MARQUETTE CITY PLANNING COMMISSION
Tuesday, April 7, 2026, at 6:00 p.m.
Commission Chambers at City Hall – 300 W. Baraga Ave.

TO: Planning Commission
FROM: Andrea Landers, Zoning Official
DATE: April 1, 2026
SUBJECT: 01-SPR-04-26 – 100 & 119 S Lakeshore Blvd (PIN: 0150942 & 0150970)

Project/Application: Final Site Plan Review for the construction of a new commercial building with hotel and restaurant use, attached parking garage, balconies, parking lot, roof patio, dumpster enclosure, landscaping, lighting, and site improvements.

LIGHT POLE DETAIL
SCALE: 1/4" = 1'-0"

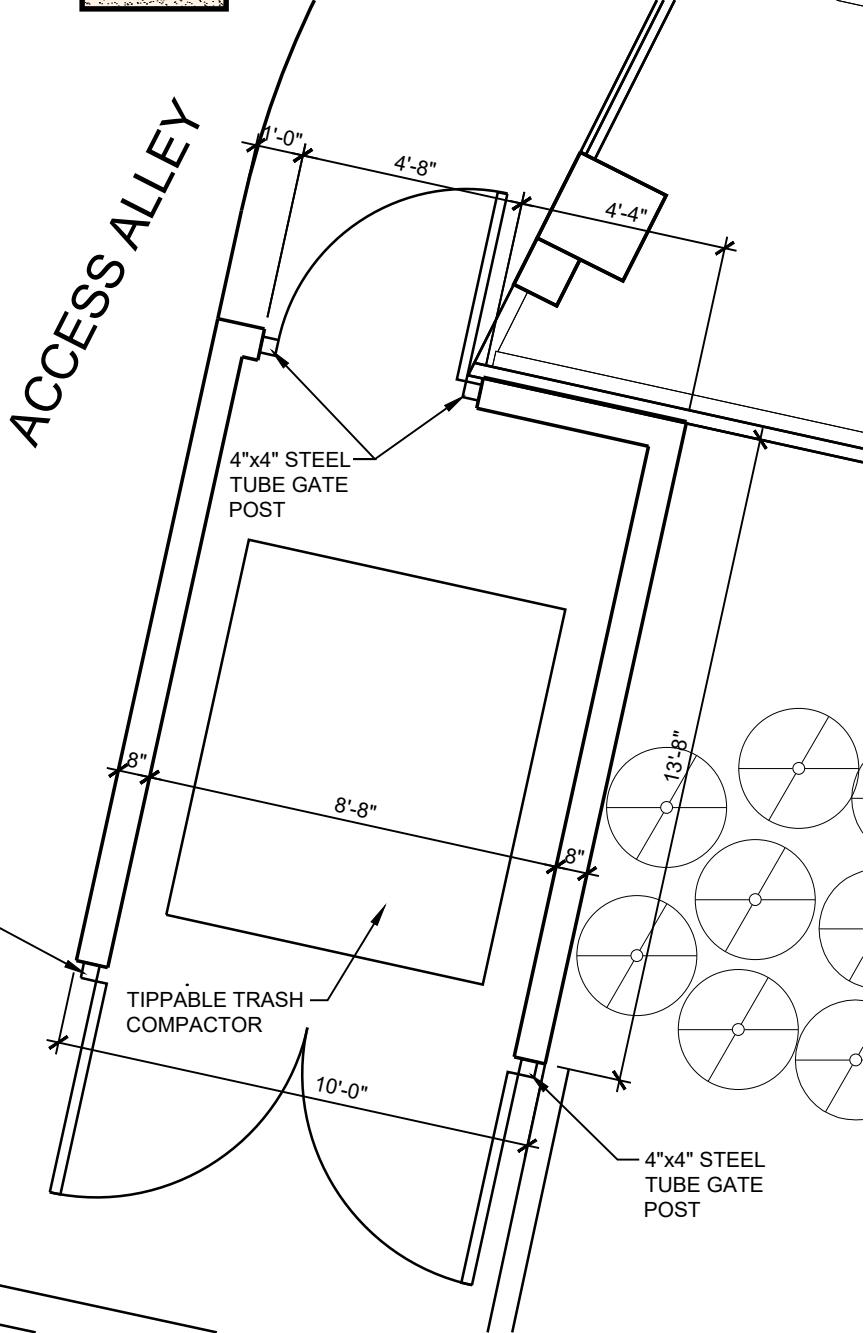
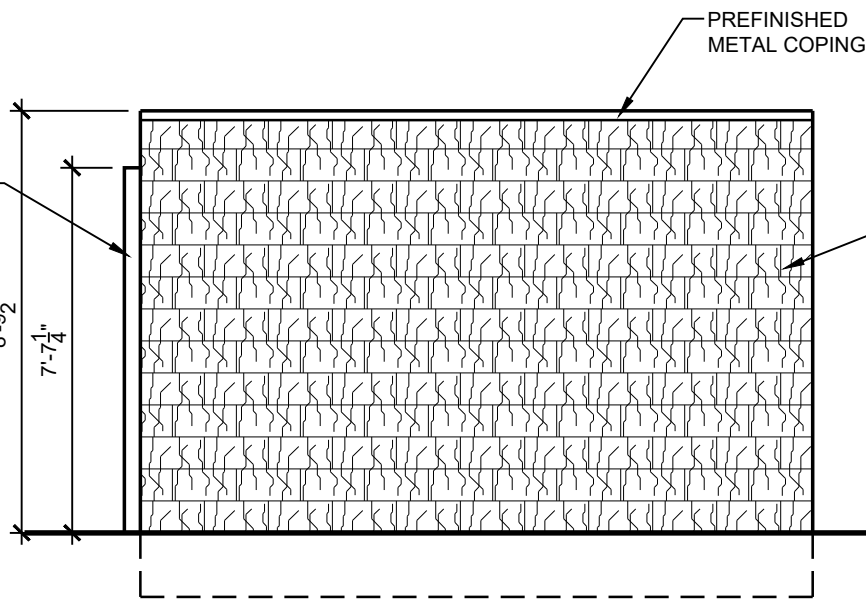
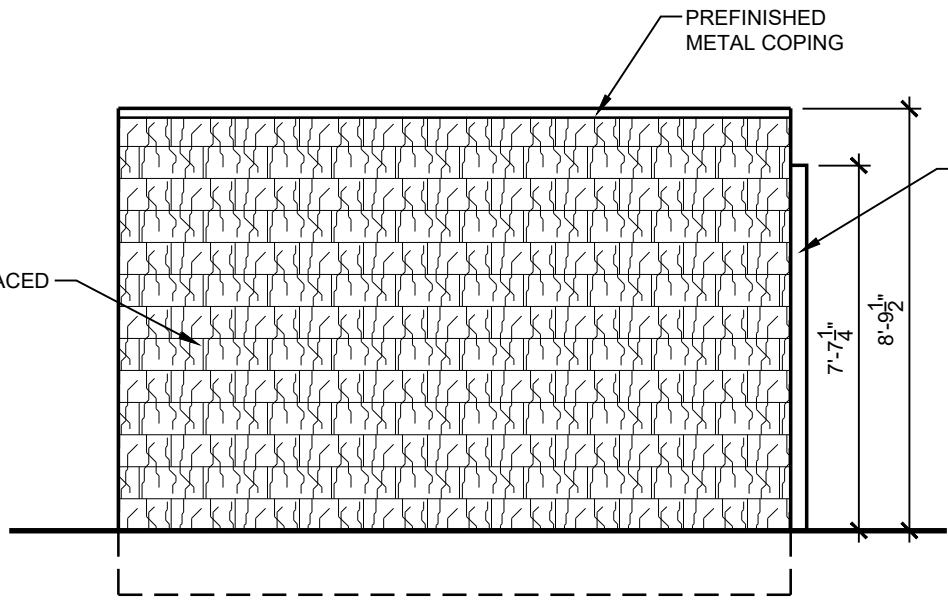
Per the site plan sheets AS1.0 and L1.0, they will store their trash inside a proposed dumpster enclosure that will consist of a +/-9-ft high split-faced CMU, and a +/-7-ft high gates with T&G treated panels over steel gate frames.

Per Sheet L1.0 they will be providing 12-ft high light poles with LED Cutoff at 70 degree fixtures.

FIRST LEVEL SITE
GRADING PLAN

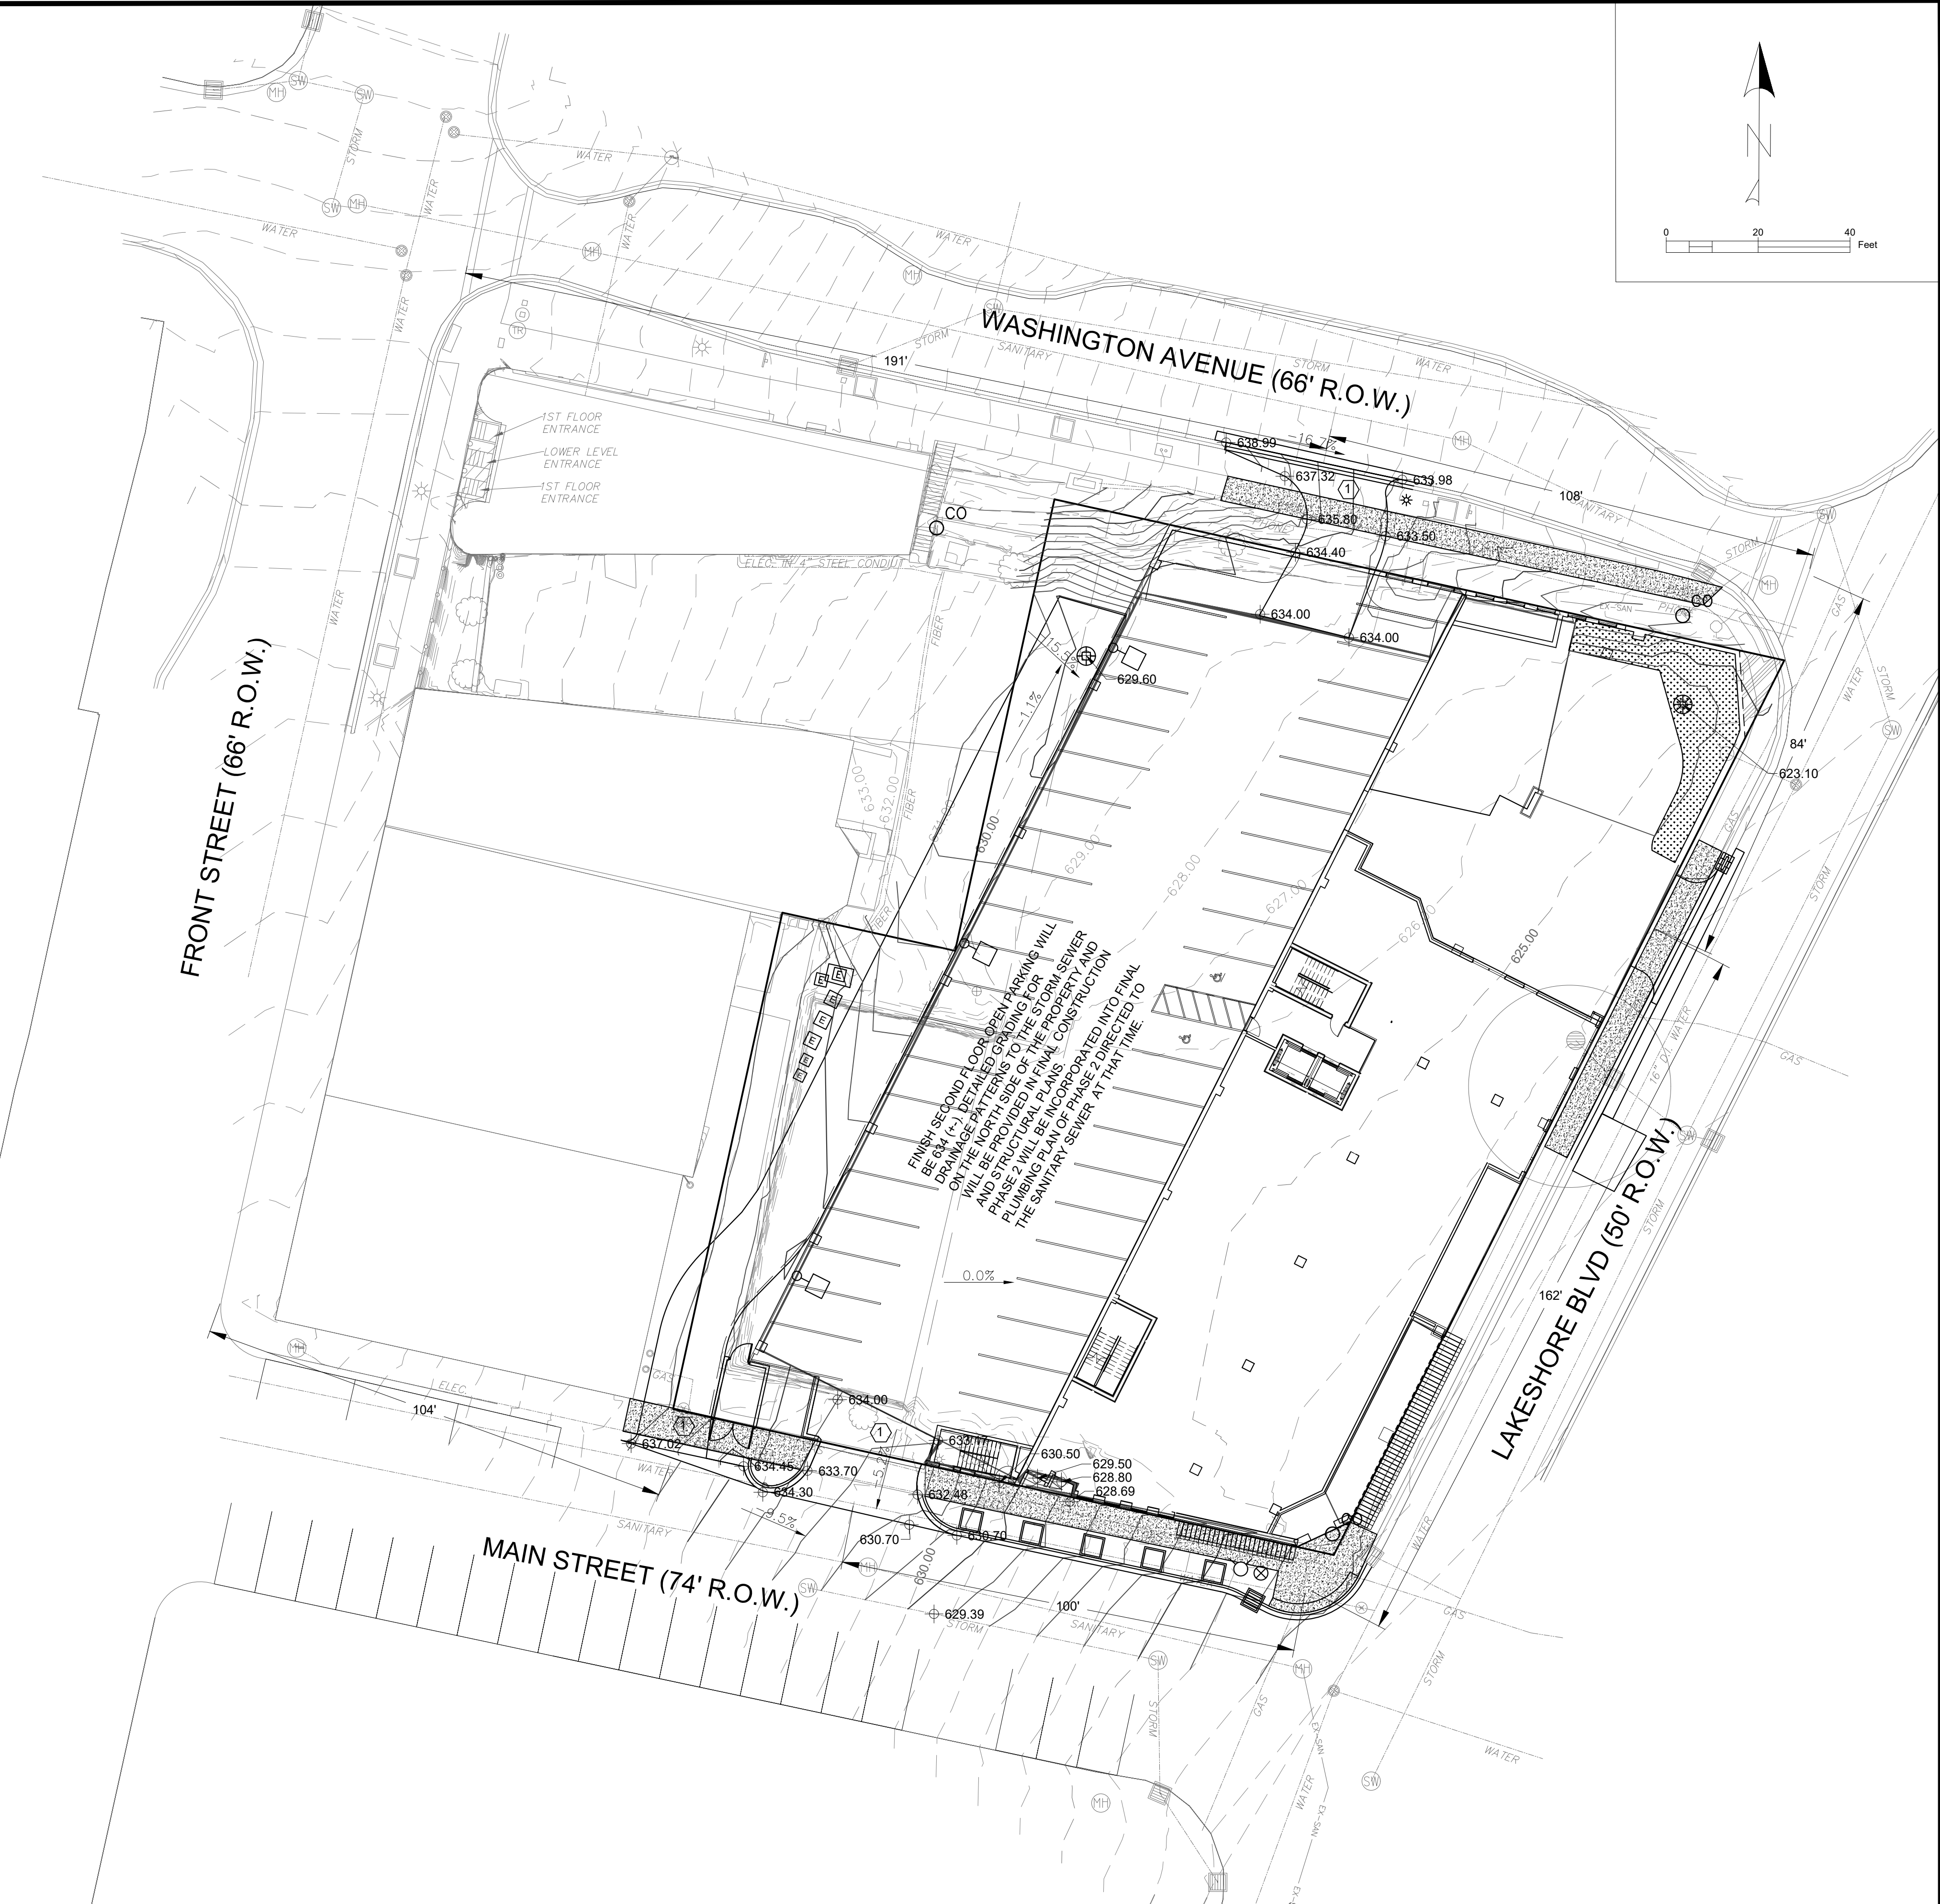
- Asphalt cuts must conform to the City's pavement cut policy.
Note will be added to comply with the City's policy.
- C-01.1
 - Sidewalks must extend through all driveway openings with a maximum grade of 2% across the driveway.
We will adjust and show in details. The existing sidewalk according to our survey data exceeds 2%. There will need to be a segment that exceeds 2% to tie back into existing sidewalk to the west.

Sheet C-01.1

Figure 6. Yard Terms

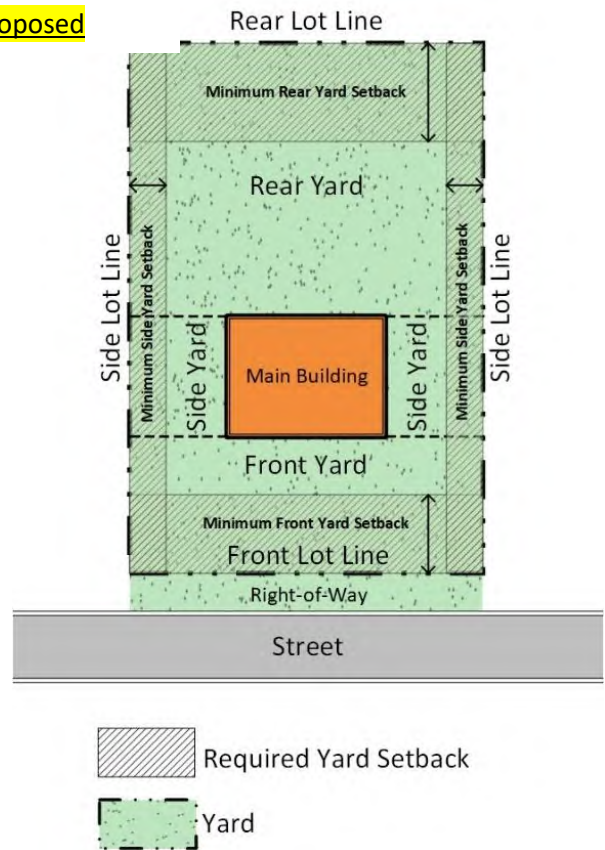
A. Landers presented the proposed addition of content to Article 54.611, sections (E) and (H). She also addressed proposed changes to Figures 6 and 7, to provide further clarification of yard and right-of-way areas on typical interior lots, corner lots, and through lots. She also presented proposed text additions to clarify definitions and meanings of three terms in Article 54.321, the G3 subdistrict of the Marquette Downtown Waterfront form-based code.

Add a Through Lot drawing as a new Figure 8. Update the existing drawings for Figures 6 & 7. Update the Front, Rear, & Side Yard definitions.
